**STAFF REPORT: JUNE 12, 2024 MEETING**  
**APPLICATION NUMBER: HDC2024-00273**  
**ADDRESS: 3417 SEMINOLE**

**PREPARED BY: A. DYE**

**HISTORIC DISTRICT: INDIAN VILLAGE**  
**APPLICANT: NICOLE RODRIGUEZ**  
**PROPERTY OWNER: NICOLE RODRIGUEZ**  
**DATE OF PROVISIONALLY COMPLETE APPLICATION: MAY 20, 2024**  
**DATE OF STAFF SITE VISIT: MAY 22, 2024**

**SCOPE: DEMOLISH GARAGE, ERECT GARAGE**

Above and right: Applicant photos.

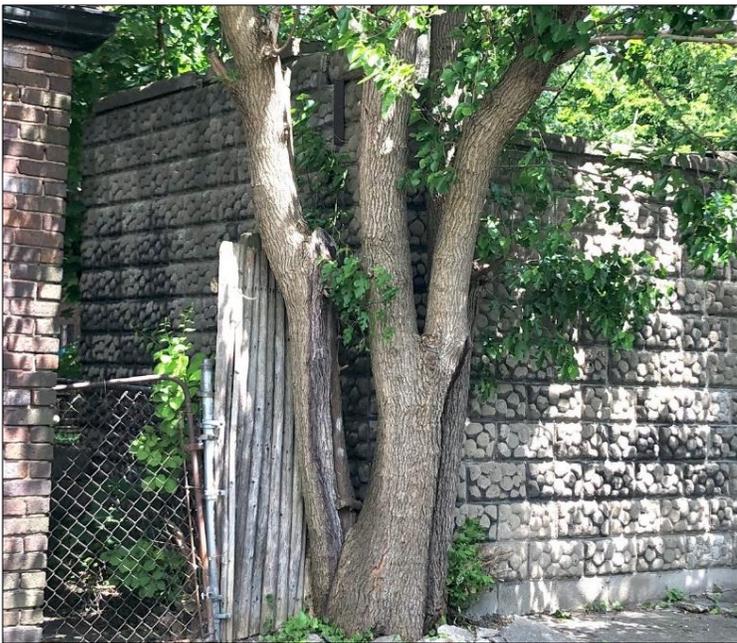
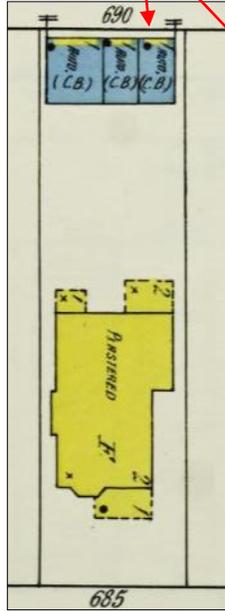
As shown in the Sanborn map, the south bay (left side) was the largest of three bays; the middle and north were about the same size.

At an unknown time, the roof and east wall of the northern bay were removed, and the overhead door on the west wall was filled in with matching concrete block (likely reused from the now-demolished east wall). Staff didn't find Commission approval for this alteration.

East elevation – facing house.

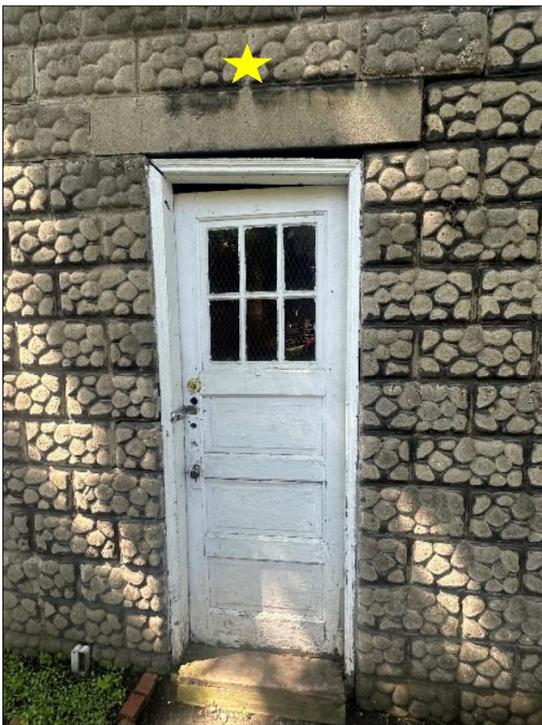
*These photos show there may be a long-standing issue with settlement, causing the frames and lintels to become unlevel. There is one area where a crack occurred in the middle of a block (circled). The doors and window openings contain historic-age wood components that are in repairable condition.*

*North wall (this interior wall is now the exterior southern wall of the missing bay).*

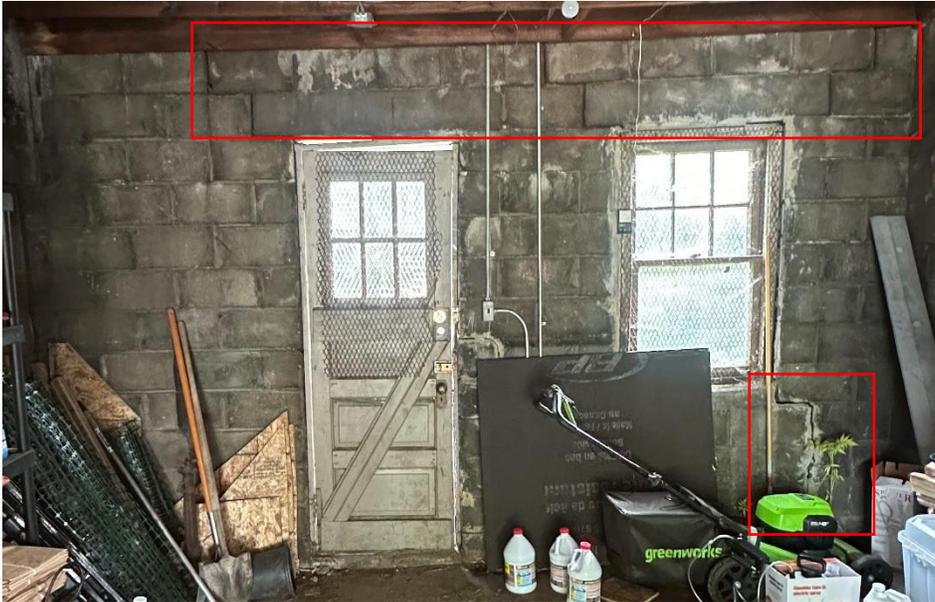
*Step crack and cracked block*

*Step cracks*

*Large step crack, broken block at top, near middle of box*

*Broken block*

- Based on the engineer’s review and the applicant’s photographs, it appears that it is possible the condition of the garage extends beyond in-situ repair, and would need to be deconstructed, a new foundation poured, and then rebuilt, reusing the historic concrete blocks (the majority of which appear to be in sound condition), wood pedestrian doors and double-hung windows. The remaining garage elements - concrete floors, flat roofing material and overhead doors can be replaced for the following reasons; the floors are interior components of the structure, and the rolled roofing and overhead metal doors are not historic age (and composite roofing was original to the structure).

South Bay  
East wall

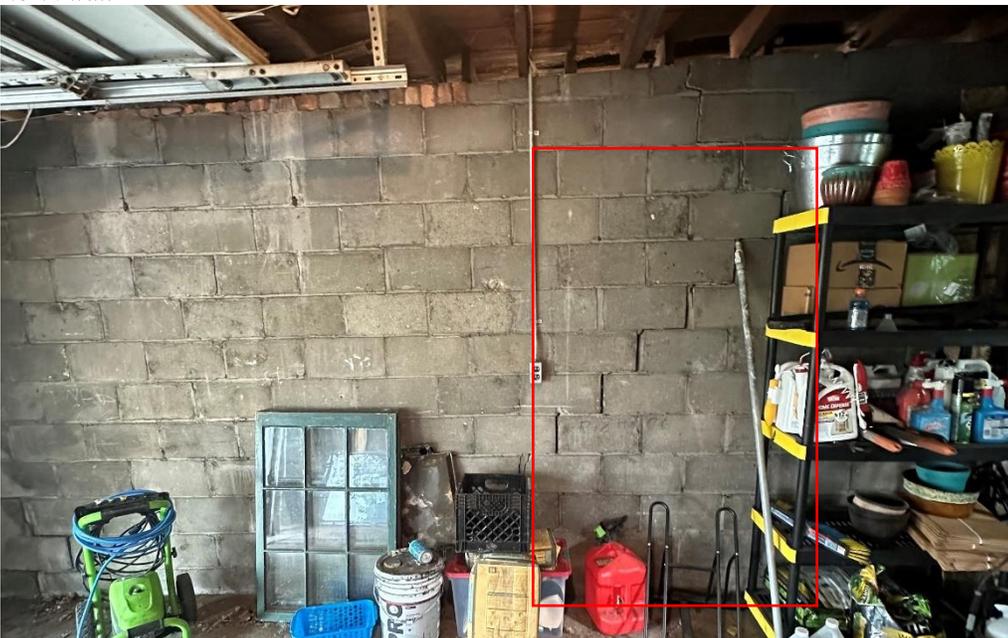
Step cracks above window and door. Cracked tile below window.

Other side of step crack, shown on page 8.

*Applicant drawings for proposed replacement garage.*

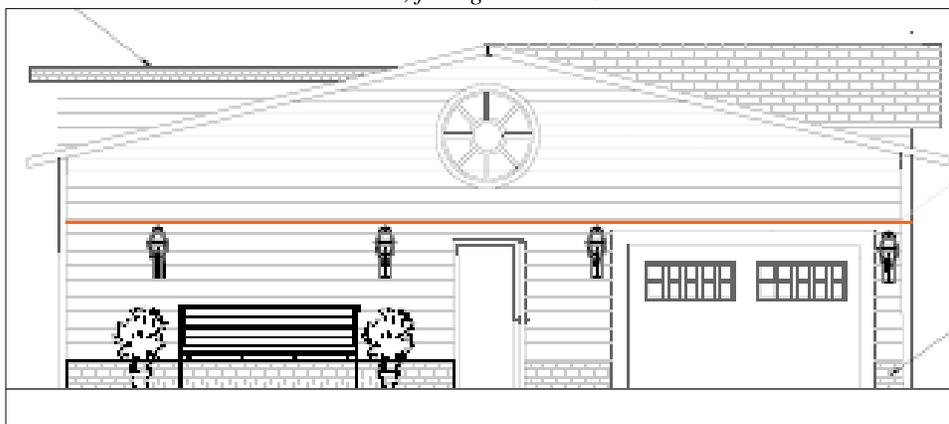
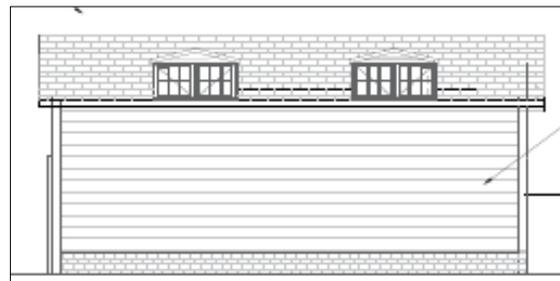
- The proposed design includes a front facing gable roof with cross gables, both of which have differing ridge heights, dormers, and multiple wall materials. These features create a complex massing and oversized design which is atypical of the environment in which it is to be placed.

- The proposed new garage is not compatible with the house and property, due to its massing, complex roof forms, multiple wall materials and design details. Erecting a "Victorian-style" garage, however defined, would be anachronistic for this property.

Staff therefore recommends that the Commission issue a Denial for the work as proposed, as it does not meet the Secretary of the Interior's Standards for Rehabilitation, specifically Standards 2, 3, 5, and 9:
